MINERALS PROGRAM INSPECTION REPORT**PHONE: (303) 866-3567**

MINE NAME: Lob Lolly Pit	MINE/PROSPECTING ID#: M-2013-066	MINERAL: Borrow material for gravel and sand	COUNTY: Archuleta
INSPECTION TYPE: Monitoring	INSPECTOR(S): Lucas J. West	INSP. DATE: May 14, 2019	INSP. TIME: 15:36
OPERATOR: Arboles Sand & Stone, LLC	OPERATOR REPRESENTATIVE: Steve Wright	TYPE OF OPERATION: 112c - Construction Regular Operation

Photo One: View west, showing the proper mine ID signage posted at the entrance to the site. The contracted mining company, Crossfire Aggregate Services has an additional sign.

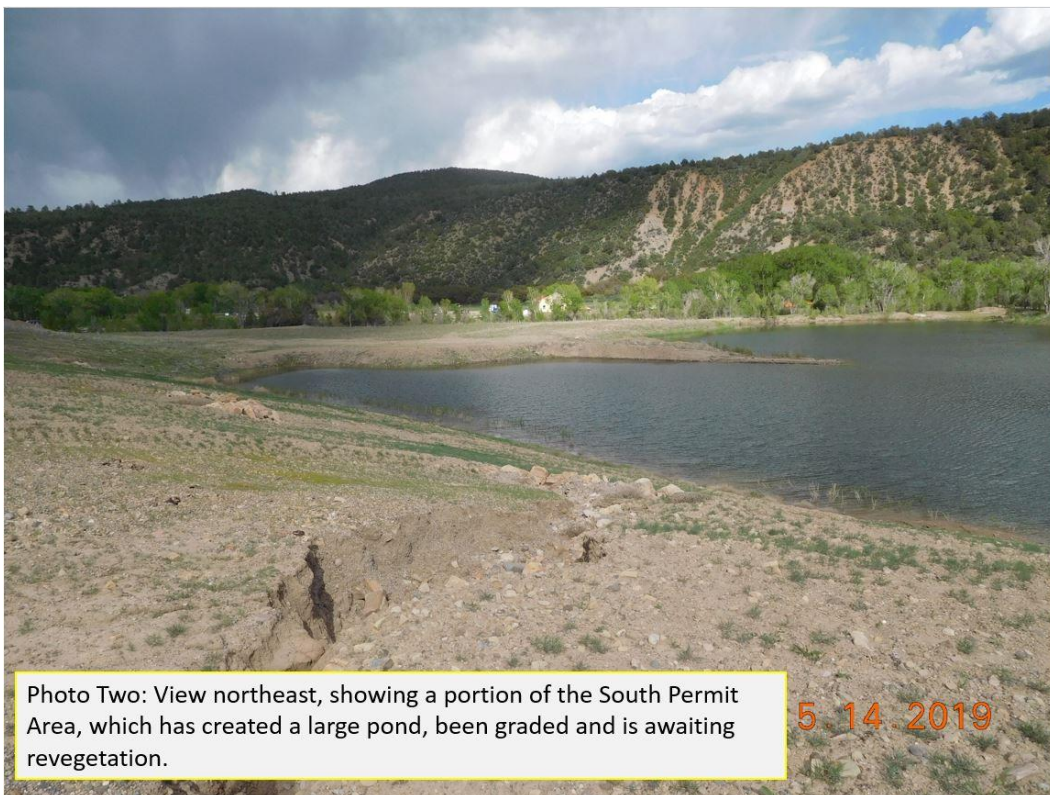
This inspection was conducted as part of the normal monitoring program established by the Colorado Division of Reclamation, Mining and Safety. The Lob Lolly pit is an active 112c operation located just off Highway near the town of Arboles, CO at nearly 6200 feet in elevation. The site consists of two segregated permit areas designated as the North Permit Area and the South Permit area, totaling 171 permitted acres that will be reclaimed to support mixed post mining land uses, including agricultural, wildlife habitat and industrial/commercial. Visual and satellite imagery estimates indicate that approximately 40 acres have been disturbed. The Permit area lies entirely on land owned by the Operator. A reclamation cost estimate update was not performed at this time as there are several details that need to be clarified. Once the Technical Revision described in this report is submitted and approved, a reclamation cost estimate update will be performed so that it more accurately represents the actual costs to achieve reclamation in accordance with the approved Reclamation Plan. In addition to the Operator and the inspector listed on page one of this report the site foreman for Crossfire Aggregate, who is contracted to conduct mining operations, was present during the inspection. Eight Photos accompany this report to illustrate the current site conditions. The site was active during the inspection in that crushing operations were taking place in the North Permit Area. The proper Mine Identification signage was posted at the entrance to the site as seen in Photo One and the permit boundaries were clearly identified in both areas.

Photo Two: View northeast, showing a portion of the South Permit Area, which has created a large pond, been graded and is awaiting revegetation.

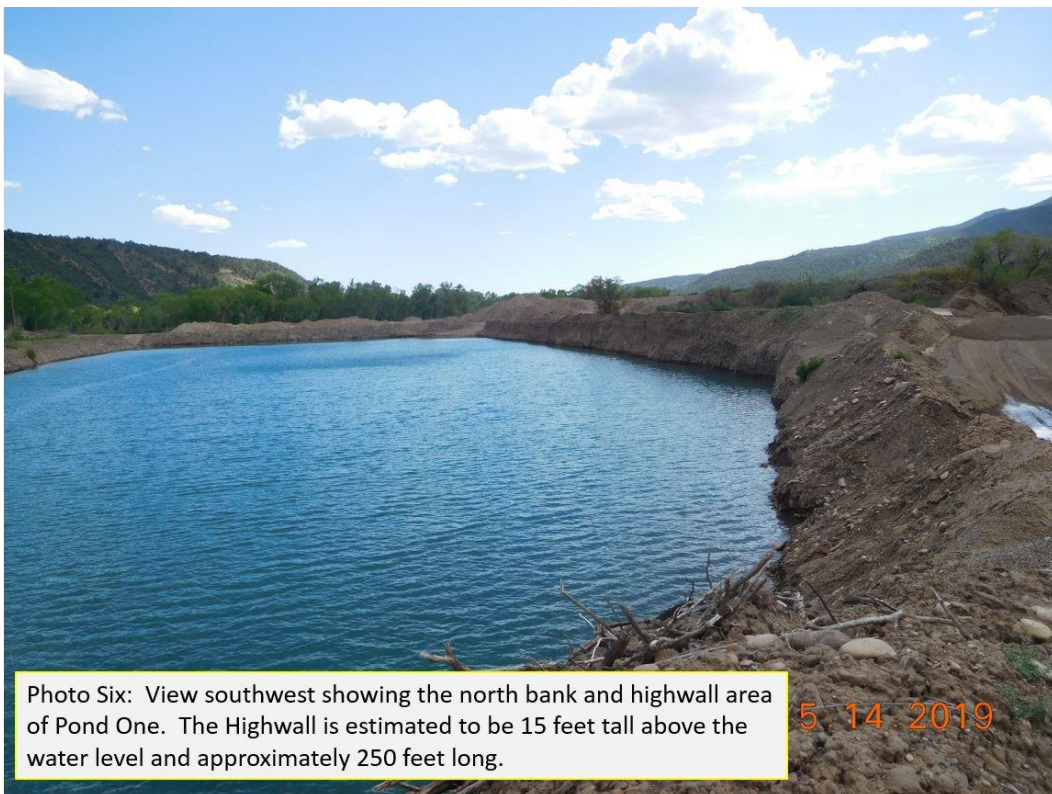
The South Permit Area consists of approximately 14 disturbed acres that are currently in final reclamation. All mining activities have been completed in this area. All grading and earth work has been completed to achieve the final reclamation topography. All grading of the upland areas appears to be nearly flat with gentle slopes leading down to the pond. All slopes, as well as the banks of the pond are 3H: 1V or shallower. Photos Two and Three show the majority of the South Permit Area. All grading appears to be stable and in good condition. A few minor erosional features were identified during the inspection, however those features will be repaired during the seedbed preparation phase of the revegetation efforts. The Operator indicated that revegetation of the area will be conducted in the coming weeks. On the west side of the access road is a small laydown yard that includes various pieces of equipment and stockpiled material that is owned by the Operator. The equipment appears to be in good condition and the stockpiles are stable. No noxious weeds were noted in
